**Re: Minor Project Refinement No. 15 for the TL 6975 San Marcos to Escondido Project**

## TL6975 San Marcos to Escondido 69 kV Project CPUC Minor Project Refinement Form

**TL6975 SAN MARCOS  
to ESCONDIDO PROJECT**

**MPR-15  
Loc #36  
San Diego County, CA**

**ATTACHMENT B**  
**MPR-15 Figure**

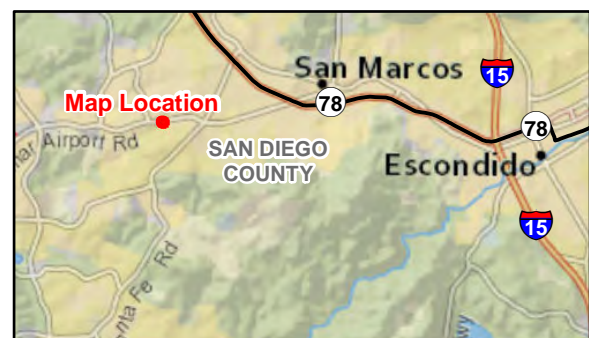
San Diego Gas and Electric (SDG&E) is requesting approval of MPR-15 for the use of a temporary construction access road to be located between San Marcos Boulevard and Location 36 for the TL6975 San Marcos to Escondido Project (Project). See **Attachment B, MPR-15 Figure** and **Attachment C, MPR-15 Site Photographs**, for an overview of the proposed MPR-15 temporary construction access road. It is important to note that use of the MPR-15 access road would eliminate the need for, and use of, the approved permanent access road to Location 36 that was included in the IS/MND, PTC, and NTP-1.

Justification for Change: During negotiations with the City of San Marcos and other landowners adjacent to Location 36 to expand the SDG&E ROW, SDG&E was informed that the approved access road to Location 36 (refer to **Attachment B, MPR-15 Figure**) could not be permanently maintained. SDG&E reviewed the option of constructing a temporary construction access road within the footprint of the approved permanent access road as well as other potential temporary access points, including the proposed MPR-15 temporary access road. SDG&E found that utilization of a more direct access point to Location 36 would require less construction and ground disturbance. SDG&E ultimately selected the MPR-15 road alignment because it was both the shortest distance from San Marcos Boulevard to the structure location and contained the most uniform topography, both of which also limit the amount of construction-related ground disturbance and site preparation.

MPR-15 would result in a net reduction in impact area, including a reduction in permanent impacts. The MPR-15 temporary access road would replace the approved permanent access road (refer to **Attachment B, MPR-15 Figure**). The proposed MPR-15 access road would be approximately 32 feet in length (from San Marcos Boulevard to the boundary of the approved Location 36 work area) and 14 feet wide (448 square feet). Whereas the approved access road is approximately 85 feet long and 12 feet wide (1,020 square feet).
